**RECLAMATION DISTRICT NO. 1601  
TWITCHELL ISLAND  
BOARD OF TRUSTEES MEETING  
TUESDAY, MARCH 17, 2026  
9:00 AM  
ENGINEER'S REPORT**

**III. DISTRICT PUMP STATION SOLAR ARRAY**

Re: RD 1601 - Pump Station Solar Array  
RFP 004-00: Elevated Platform for Transformer

## Change Request

1 SWITCHBOARD PAD DETAIL  
SCALE: 1" = 10'

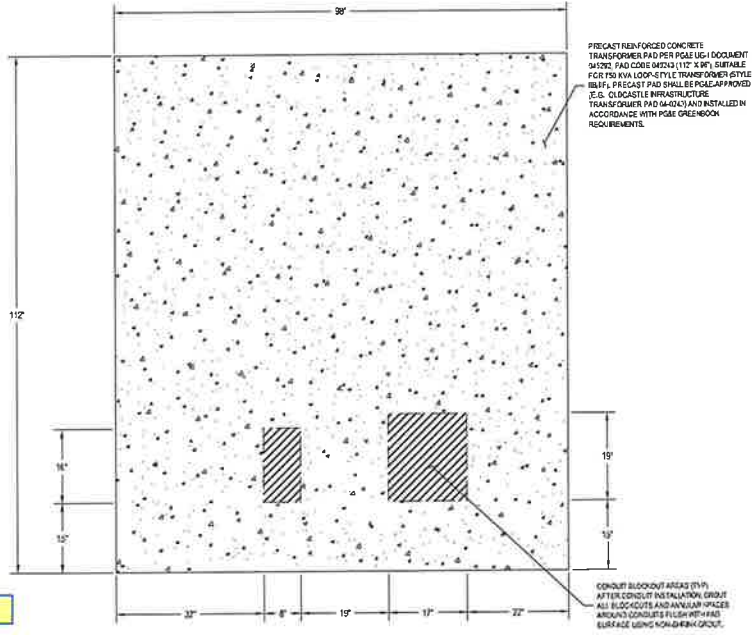
2. Source and install a PGE approved 112"x98" precast reinforced concrete pad to support the transformer. See attached Exhibit A.1 for placement and locations details and Exhibit A.2 for product requirements.

3. Provide any additional cost not anticipated in Alternate Bid Item 13b to construct a cast-in-place concrete slab-on-grade to support the switchgear according to the attached Exhibits A.2 and Switchgear Slab of Grade Detail and according to applicable project specifications.

PRECAST REINFORCED CONCRETE TRANSFORMER PAD PER PG&E UGI DOCUMENT (SUITE: PAD CORR 0420) 11/17/19. SURFACE FOR 150 KVA LOCK-STYLE TRANSFORMER (STYLE 181FF). PRECAST PAD SHALL BE PG&E APPROVED (I.E. G. CIRCULAR REINFORCEMENTS). TRANSFORMER PAD (04-02) AND INSTALLED IN ACCORDANCE WITH PG&E GREENBOOK REQUIREMENTS.

CONDUIT BLOKOUT AREAS (P.V.P.) AFTER CONDUIT INSTALLATION, GROUT ALL BLOKOUTS AND ANGULAR SPACES AROUND CONDUITS FLUSH WITH PAD SURFACE USING NON-SHINK GROUT.

On-Island Borrow Source and haul route.

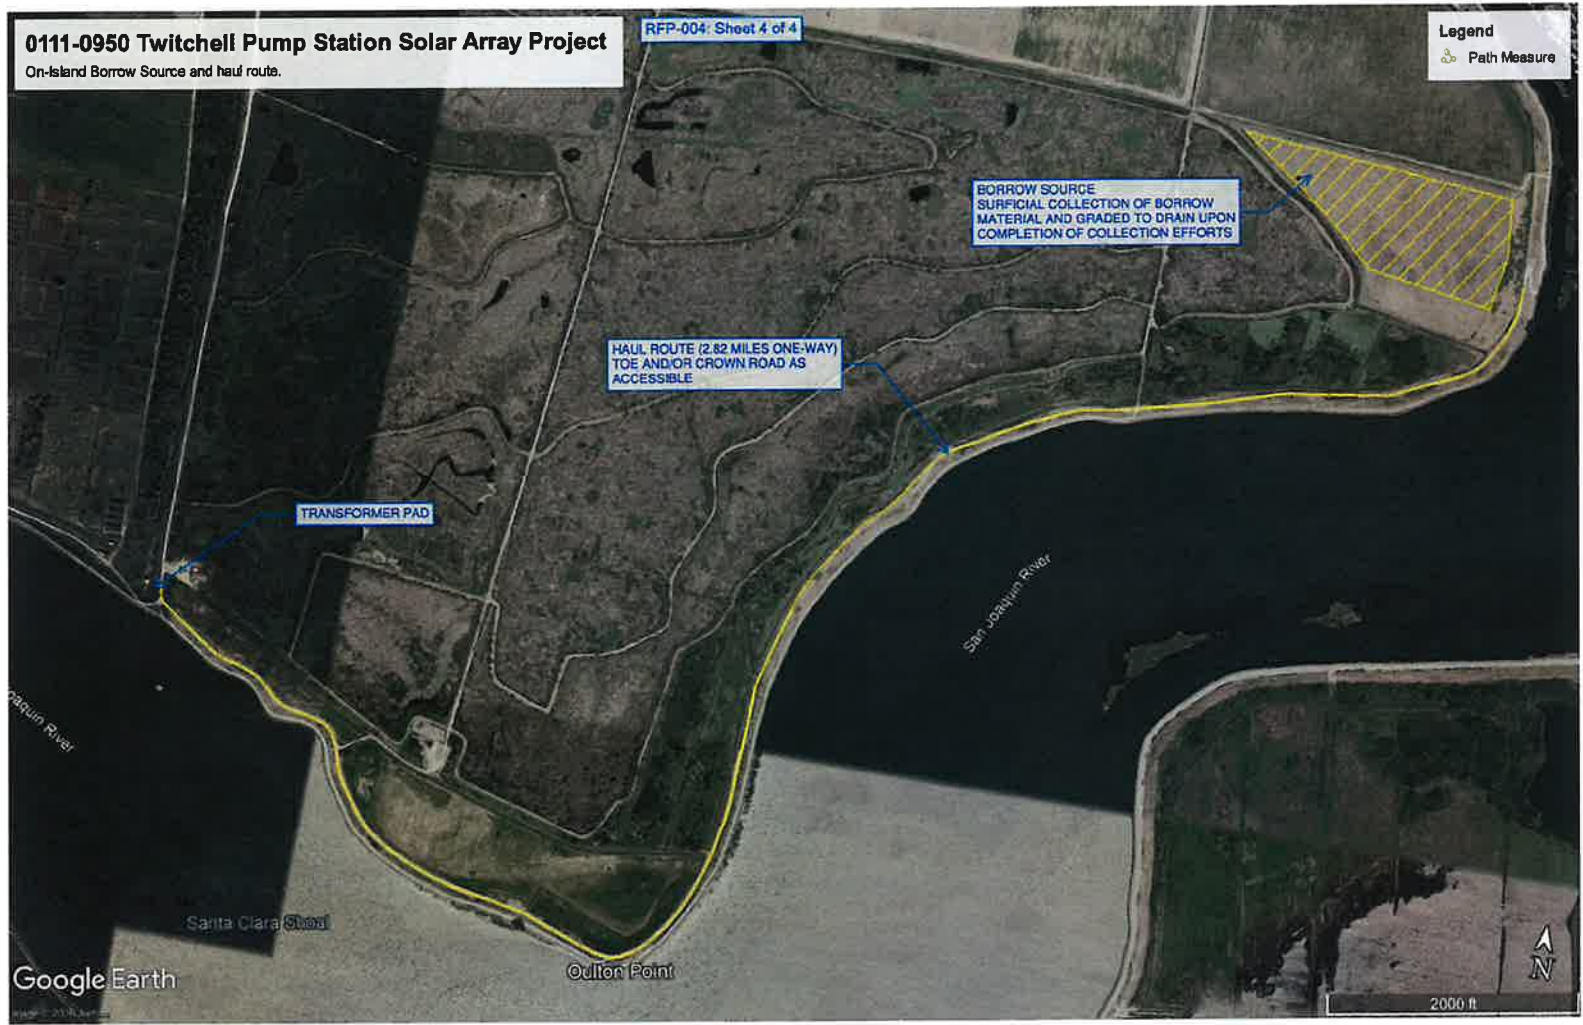
- a. Harvest approximately 530 CY of pad fill soils materials from the on-island borrow site approximately 2.8 mi E of the site and haul to Equipment Pad location. See attached haul route exhibit for routing and restrictions.
